Merged Document Report

Application No.: PL8504

Plat of Roy Smith Plaza Block 1, Lot 8

**Preliminary Utility Map of
 Roy Smith Plaza
 Block 1, Lot 8**

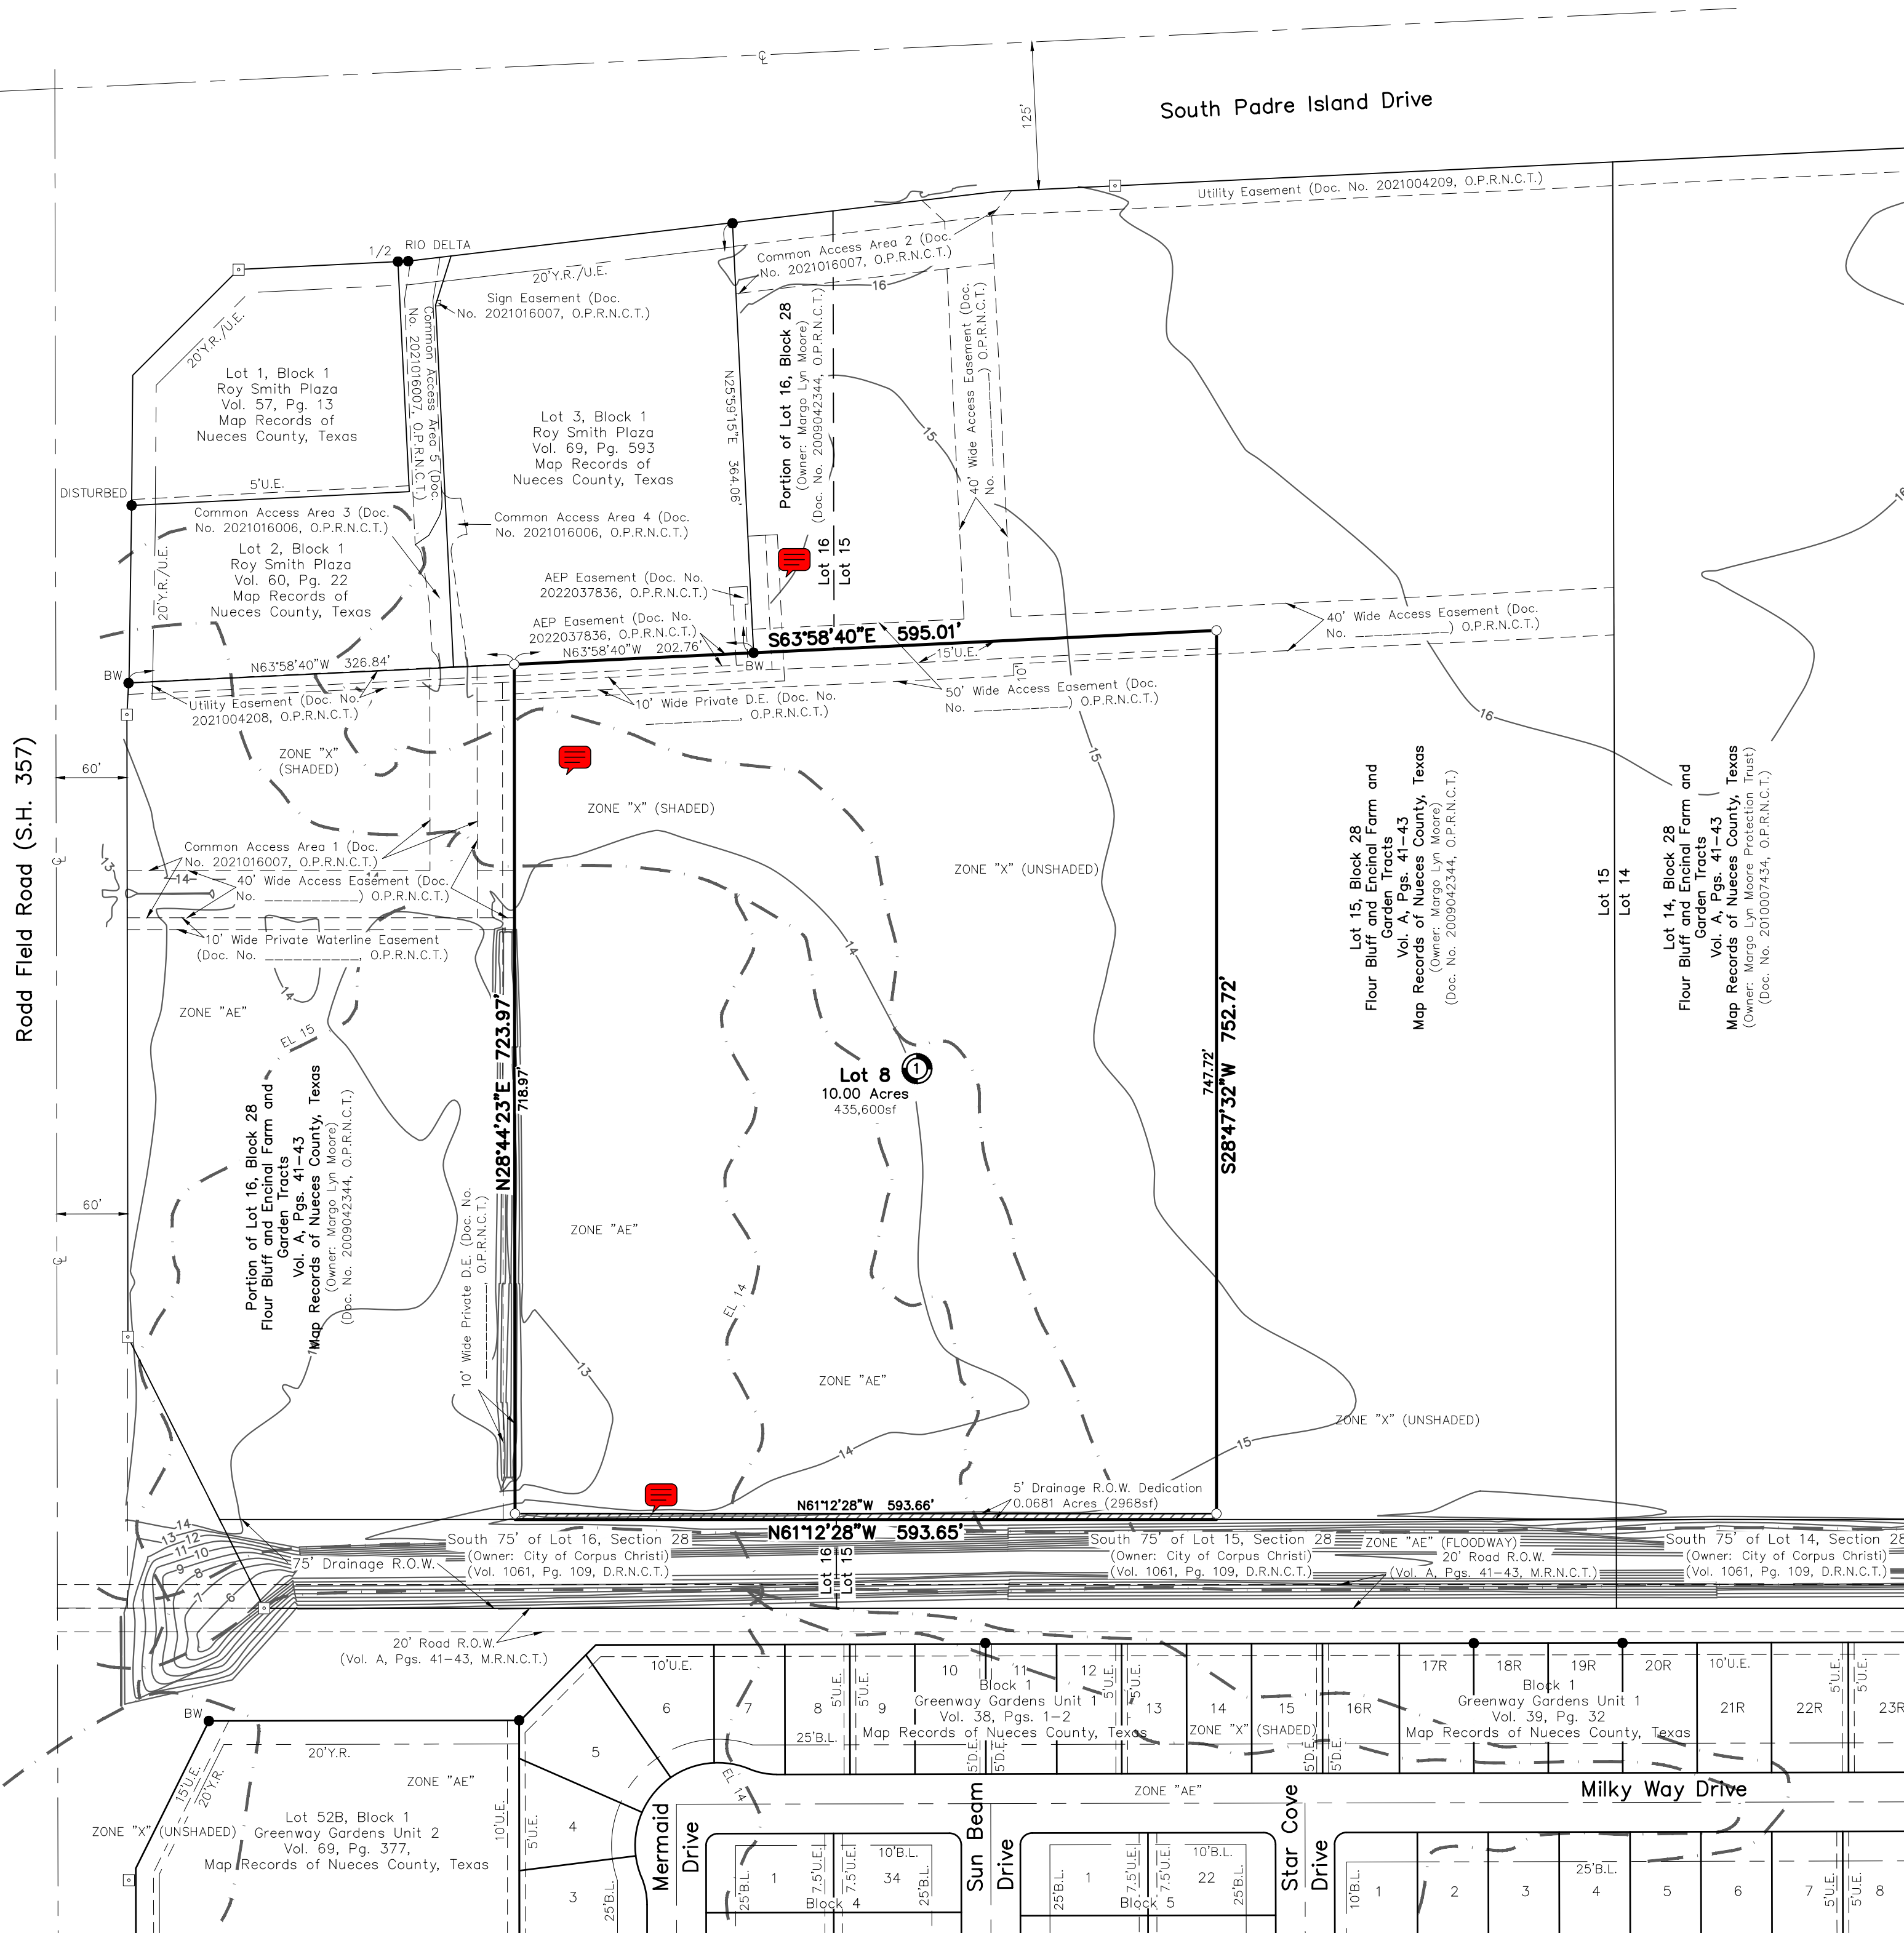
Comment ID	Page Reference	Annotation Type	Author : Department	Status	Review Comments	Applicant Response Comments
21	P001	Note	Melanie Barrera : DS	Open	PW-STW: Add as plat note, not just on SWQMP: During the development of the site, any increase in stormwater runoff flow rates must be mitigated in accordance with UDC 8.2.8.A, 8.2.8.B, and IDM 3.05 resulting in no adverse impacts between existing conditions and proposed conditions.	
11	P002	Note	Alex Harmon : DS	Open	Williams is identified as a Primary Collector (C3) street on the Urban Transportation Plan and is proposed to extend to the south of these lots from Rodd Field to Lexington. Show the typical crosssection for this street. Unless otherwise approved by the City and/or Director of Public Works.	
23	P002	Note	Melanie Barrera : DS	Open	PW-STW: Please confirm storm mitigation efforts will be privately maintained with a plat note.	
16	Utility Map	Note	Alex Harmon : DS	Open	Informational: Approval of a plat does not approve the layout of public utilities, including but not limited to water, wastewater, stormwater, SWQMP, and roadways. These items are only approved via Public Improvement Plans, which are required at time of final plat.

1	P001	Note	Mark Zans : LD	Open	<p>TxDOT comments- Please add the below 4 notes regarding access/drainage onto the state roadway system.</p> <p>•No increase in stormwater discharge to the State right-of-way will be accepted by TxDOT.</p> <p>•TxDOT permits will be issued in accordance with</p>

Comment ID	Page Reference	Annotation Type	Author : Department	Status	Review Comments	Applicant Response Comments
					<p>access management standards and all applicable state and federal laws, including relevant rules and regulations. Considerations will include access connection spacing, materials, geometrics, accessibility, and other design specifications, as well as the impact on drainage and hydraulics, utility location or relocation, and environmental effects resulting from the requested construction of an access connection (43 Tex. Admin. Code § 11.52, 2020).</p> <ul style="list-style-type: none"> •□Drainage improvements must accommodate runoff from the upstream drainage area in its anticipated maximum "build-out" or "fully developed" condition and should be designed to prevent overloading the capacity of the downstream drainage system. •□If the owner responsible for maintaining the permanent stormwater or water quality control fails to maintain it to TxDOT ROW standards, the owner must rectify the issue. •□Any development that anticipates an increase in existing traffic generation may be required to conduct a traffic study. The necessary improvements identified in the traffic study may need to be constructed by the developer, based on TxDOT's discretion and approval, prior to the access connection being established

2	P001	Note	Mark Zans : LD	Open	Plat is a Final plat.	
3	P001	Note	Mark Zans : LD	Open	This plat is on the 30-day tract for approval, approval with Conditions, or disapproval by 11/13/2024. The deadline for revisions to be submitted is 11/4/2024	
4	P001	Note	Mark Zans : LD	Open	The plat will be recommended as Conditional Approval for Resolution comments received and that have remained Open and unmet.	
5	P001	Note	Mark Zans : LD	Open	A request or response may be made for an additional 30 days for Public Notice plat with a Waiver or to resolve Open comments. This request must be made directly to Development Services within the 30-day initial period.	
6	P001	Note	Mark Zans : LD	Open	<p>Fire comments 1-9:</p> <p>1□Plat□Note: All code reference is based on currently adopted International Fire Code (IFC) 2021 and Corpus Christi Water Distribution Standards.</p> <p>2□Plat□"Commercial Development shall have a fire flow of 1,500 GPM with 20 psi residual Fire hydrant every 300 feet and operational."</p>

Comment ID	Page Reference	Annotation Type	Author : Department	Status	Review Comments	Applicant Response Comments
					<p>3 Plat 507.5.1 (amendment) Where Required: All premises, other than one-family detached dwellings, where buildings or portions of buildings are located more than 150 feet from a fire hydrant shall be provided with approved on-site hydrants and water mains capable of supplying the fire flow require by the fire official. The minimum arrangement being so as to have a hydrant available for distribution of hose to any portion of building on the premises at distances not exceeding 300 feet. Exception: For buildings equipped with an approved automatic sprinkler system, the distance requirement shall be 500 feet.</p> <p>4 Plat 507.5.4 Obstruction. Unobstructed access to fire hydrants shall be maintained at all times. The fire department shall not be deterred or hindered from gaining immediate access to fire protection equipment or fire hydrants. Note: Hose lay from a hydrant will not cross an arterial street.</p> <p>5 Plat 912.2.3 (amendment) Proximity to Hydrant: Fire department connections (FDC) for each sprinkler system or standpipe system shall be located not more than 100 feet from the nearest fire hydrant connected to an approved water</p> <p>6 Plat 503.1.1 (amendment) Buildings and facilities: Approved fire apparatus access roads shall be provided for every facility, building, or portion of a building hereafter constructed or moved into or within the jurisdiction. The fire apparatus access road shall allow access to three (3) sides of buildings in excess of fifteen thousand (15,000) square feet and all sides for buildings in excess of thirty thousand (30,000) square feet.</p> <p>7 Plat 3310.1 Required access. Approved vehicle access for firefighting shall be provided to all construction or demolition sites. Vehicle access shall be provided to within 100 feet of temporary or permanent fire department connections. Vehicle access shall be provided by either temporary or permanent roads, capable of supporting vehicle loading under all weather conditions. Vehicle access shall be maintained until permanent fire apparatus access roads are available.</p> <p>8 Plat D102.1 Access and loading. Facilities, buildings, or portions of buildings hereafter constructed shall be accessible to fire department apparatus by way of an approved fire apparatus access road with an asphalt, concrete or other approved driving surface capable of supporting the</p>

Comment ID	Page Reference	Annotation Type	Author : Department	Status	Review Comments	Applicant Response Comments
					<p>imposed load of fire apparatus weighing at least 75,000 pounds.</p> <p>9 Plat 503.1.1 (amendment) Buildings and facilities: During construction, when combustibles are brought on to the site in such quantities as deemed hazardous by the fire official, access roads and a suitable temporary supply of water acceptable the fire department shall be provided and maintained.</p>	
7	P001	Note	Mark Zans : LD	Open	<p>Fire comments 10-18</p> <p>10 Plat 503.2.1 Dimensions. Fire apparatus access roads shall have an unobstructed width of not less than 20 feet, exclusive of shoulders and an unobstructed vertical clearance of not less than 13 feet 6 inches.</p> <p>11 Plat D103.1 Access road width with a hydrant. Where a fire hydrant is located on a fire apparatus access road, the minimum road width shall be 26 feet, exclusive of shoulders.</p> <p>12 Plat "The minimum required width of 20 feet that shall be maintained means a clear unobstructed path that allows the passage of fire apparatus.</p> <p>1. Where Fire Apparatus Access is constructed to the minimum of 20 feet, no parking is allowed within the fire apparatus lane.</p> <p>2. Where a fire hydrant is located on the street, the minimum unobstructed clearance shall be 26 feet. In this instance, no parking is allowed on one side of the street.</p> <p>3. The minimum UDC residential street width is 28 ft. curb to curb. Any parking along the street that reduces the width to less than 20 ft. is prohibited and the Fire Code Official and will require painting "NO PARKING-FIRE LANE" along one side of the street."</p> <p>13 Infor. "Note: Calculated Turning Radii for Fire Apparatus: Inside Turn: 20 ft. 3 in. Curb to curb: 36 ft. 8 in. Wall to wall: 44 ft. 8 in."</p> <p>14 Plat 503.4 Obstruction of fire apparatus access roads. Fire apparatus access roads shall not be obstructed in any manner, including the parking of vehicles. The minimum widths and clearances established in sections D103 shall always be maintained.</p>

Comment ID	Page Reference	Annotation Type	Author : Department	Status	Review Comments	Applicant Response Comments
					<p>15 Plat 503.3 Marking: Where required by the fire code official, approved signs, or other approved notices the include the words NO PARKING-FIRE LANE shall be provided for fire apparatus access roads to identify such roads to prohibit the obstruction thereof. The designation of a fire lane can be marked with conspicuous signs which have the words: " Fire Lane-No Parking" at 50-foot intervals. In lieu of signs, fire lanes may be marked along curbing with the wording, "Fire Lane-No Parking" at 15-foot intervals.</p> <p>16 Plat Table D103.4 Requirements for Dead-end fire apparatus access roads. Turnaround provisions shall be provided with a 96-foot diameter cul-de-sac.</p> <p>17 Plat 503.2.5 Dead ends. Dead-end fire apparatus access roads more than 150 feet in length shall be provided with an approved area for turning around fire apparatus.</p> <p>18 Plat Commercial development of the property will require further Development Services review.</p>

**Preliminary Utility Map of
 Roy Smith Plaza
 Block 1, Lot 8**

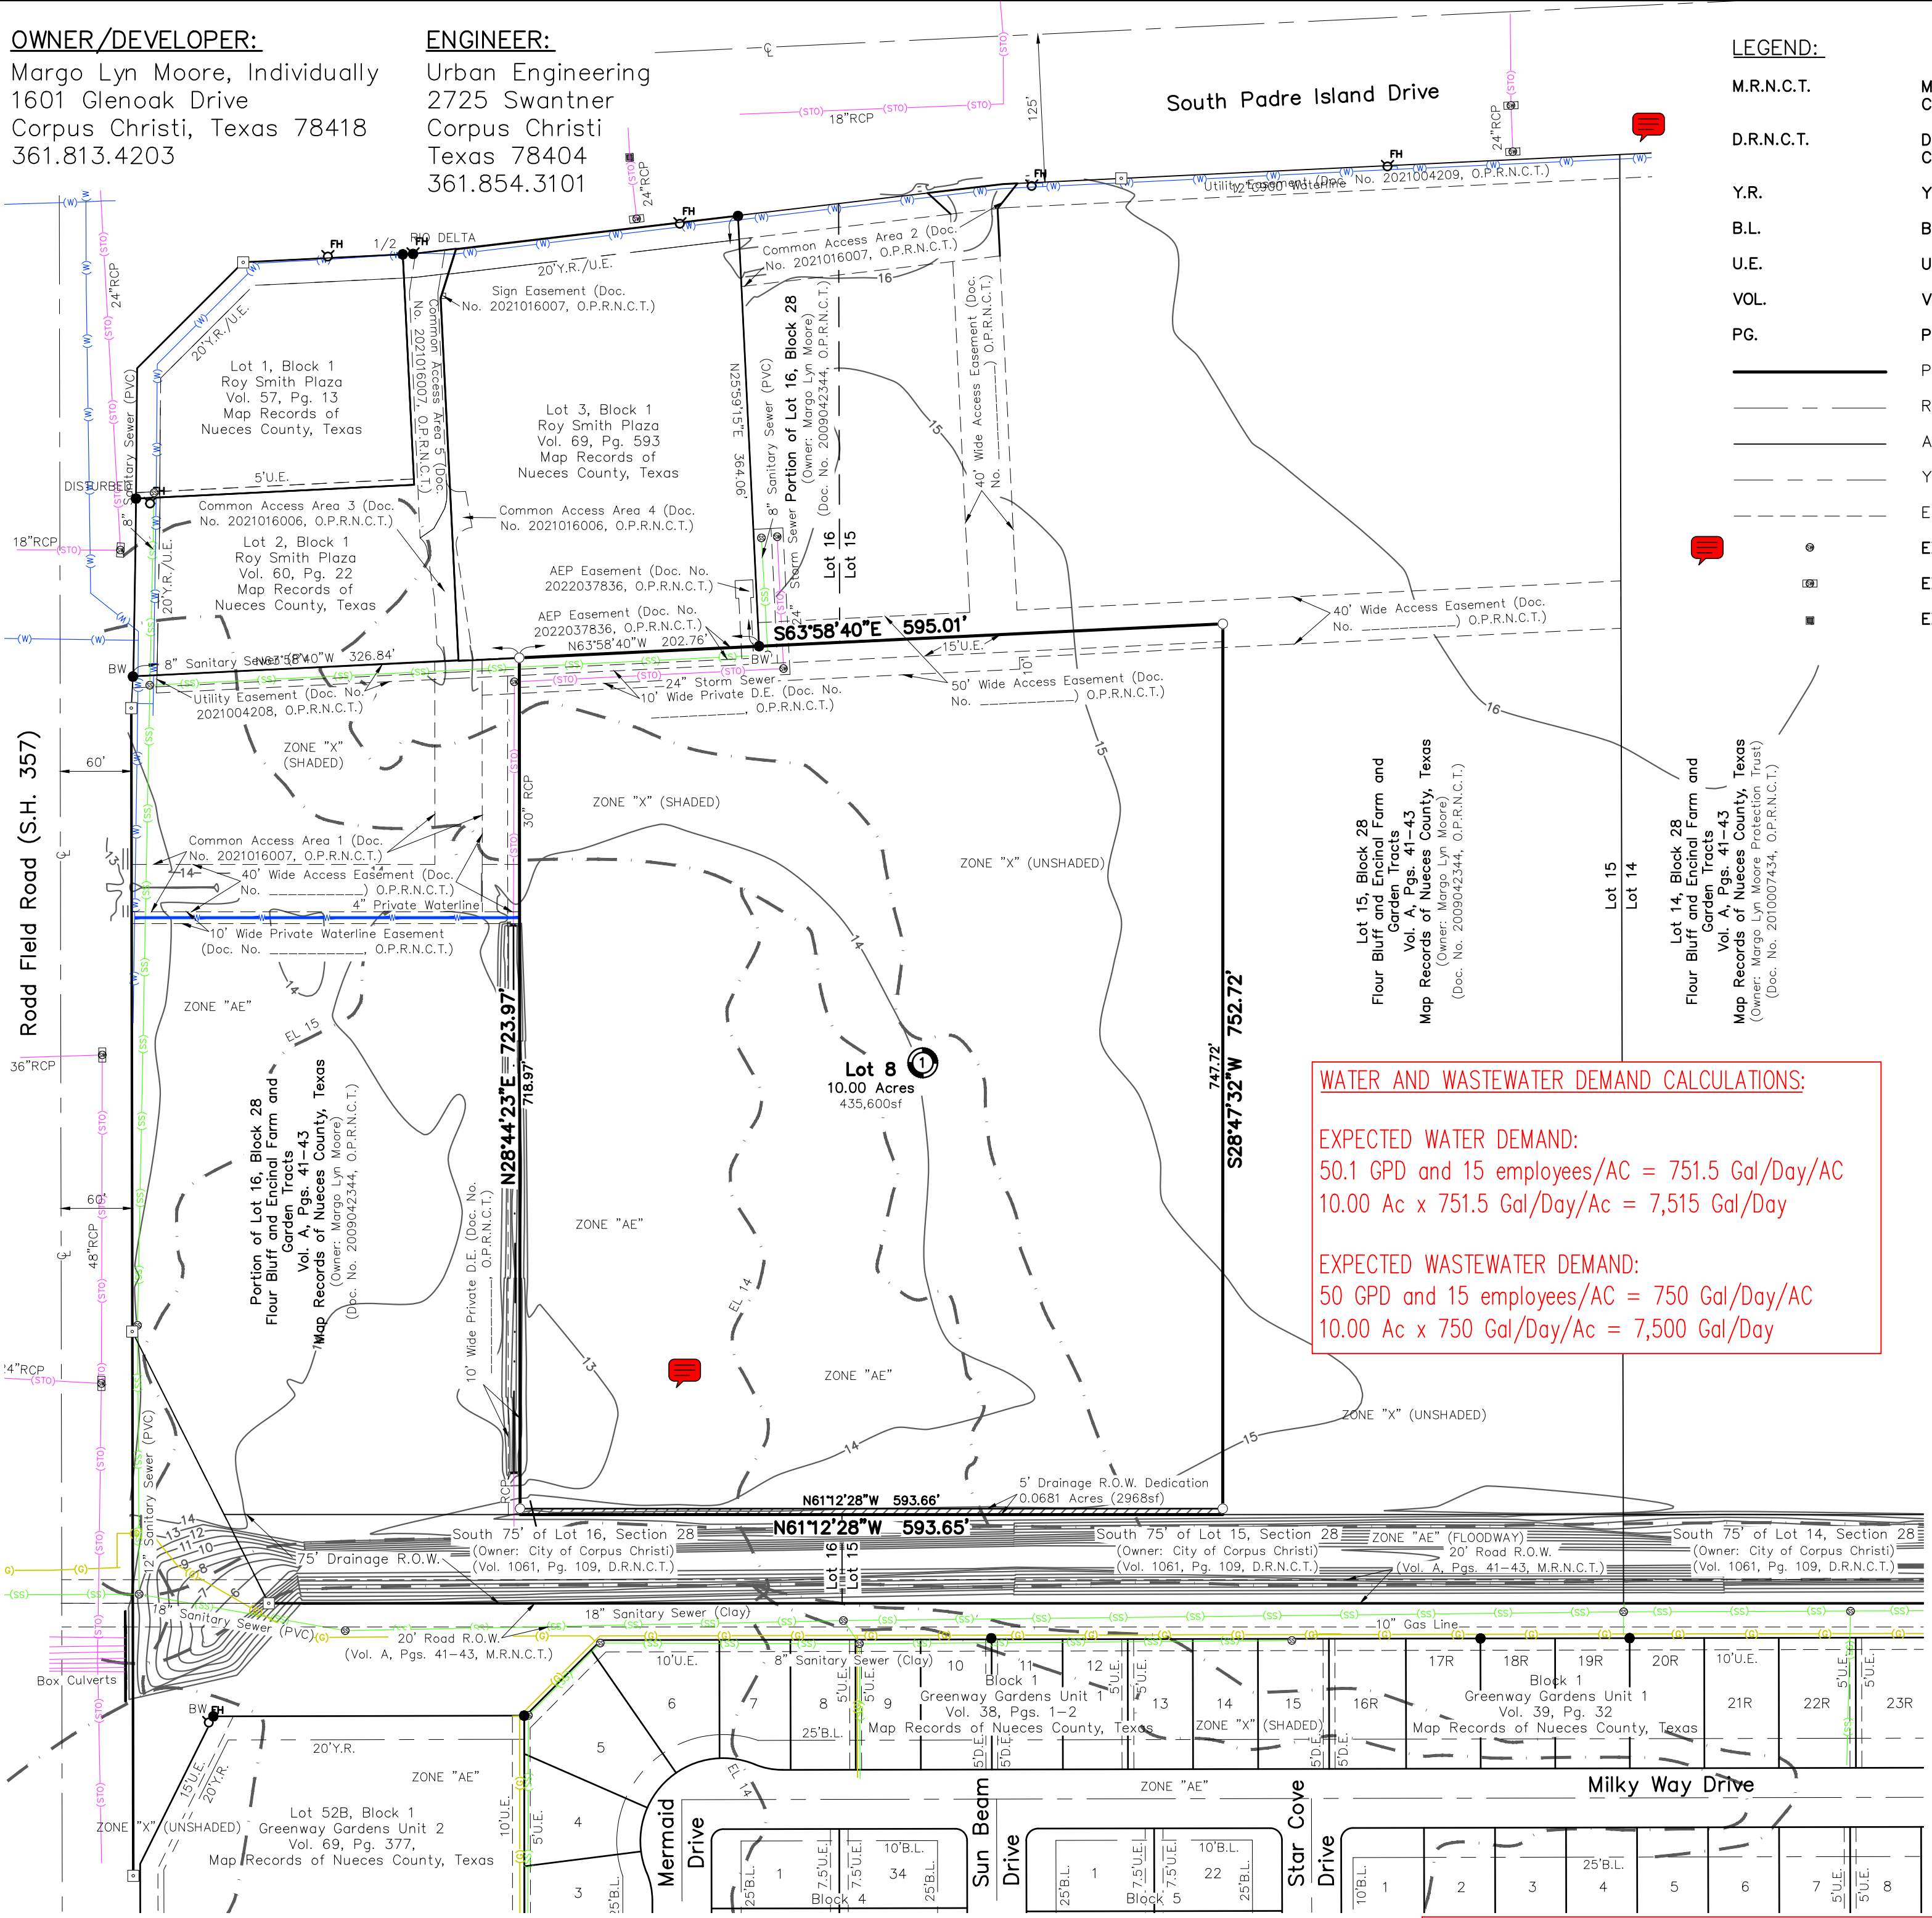
Comment ID	Page Reference	Annotation Type	Author : Department	Status	Review Comments	Applicant Response Comments
18	Utility Map	Note	Alex Harmon : DS	Open	<p>Per UDC 8.1.5., All required improvements shall be designed and installed in order to provide for a system of utilities, storm water and streets and to create continuity of improvements among adjacent properties.</p> <p>Has consideration been given to how Lot 9 will receive water and wastewater?</p>	
14	SWQMP	Note	Alex Harmon : DS	Open	<p>Show boundaries of existing wetlands on SWQMP and Plat for the following reasons:</p> <p>1. Approval from the USACE is needed prior to recordation/construction in wetland areas. Ensure the wetlands are not on site.</p> <p>2. Per City of Corpus Christi - Code of Ordinances Ch 14, Art X, Sec 14-1003, a SWQMP should identify any environmentally sensitive area that is on the site, or that would be sensitive to storm water pollution from the site.</p>
